## RESPONSE TO REQUEST FOR ADDITIONAL INFORMATION

### APR1400 Design Certification

RAI No.: 407-8447

### **Question No. 19-03-27**

Schematic diagram of the raw water tank and FLEX equipment connection point

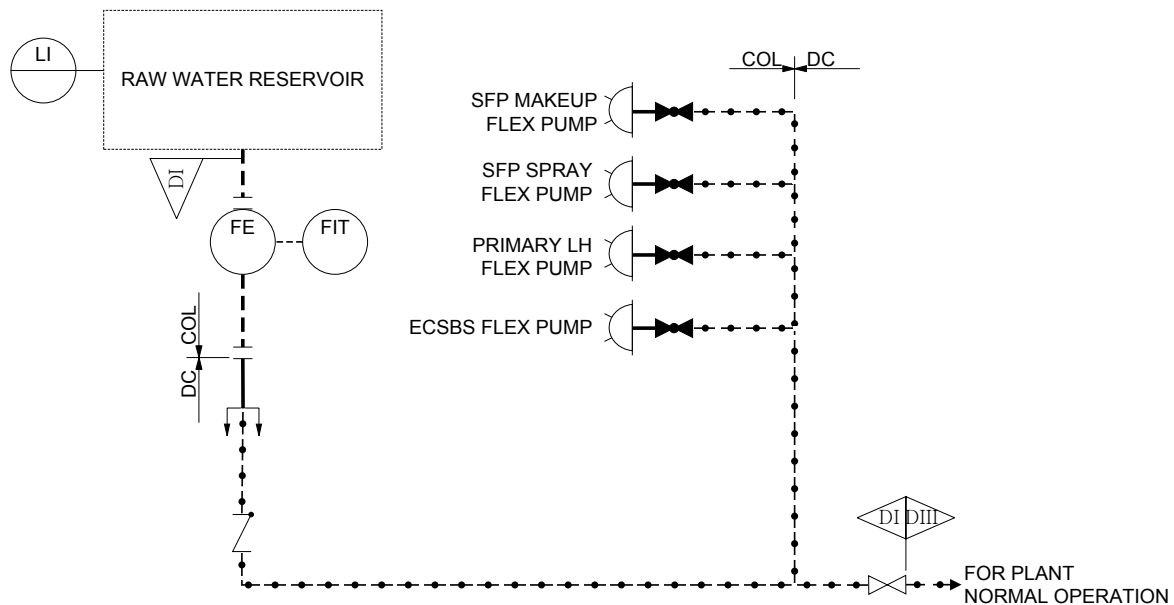
DCD Tier 2, Section 19.3.2.3.2 states that, in Phase 2 and Phase 3, makeup water will be taken from raw water tank (RWT) using a portable pump. It is not clear in the DCD whether there is a level instrument for the RWT being included in the design.

The applicant is requested to explain the design of RWT level instrument, or justify its elimination.

The design of the raw water system including the raw water tank is not involved in the DC phase. The level instrument will be provided to the raw water tank. To design the raw water tank

including level instrument, the site specific design data (water demand, site location, raw water source, etc.) will be determined during the construction phase. While the level instrument is provided for the raw water tank, specific design data is not determined (type, level setting, level alarm, etc.). A conceptual schematic diagram for the raw water tank is shown below as a guide for helping the NRC staff understand this response. Additionally, the information on the required makeup volume and water source in BDBEE is provided in Technical Report, APR1400-E-P-NR-14005-P, Table B-3.
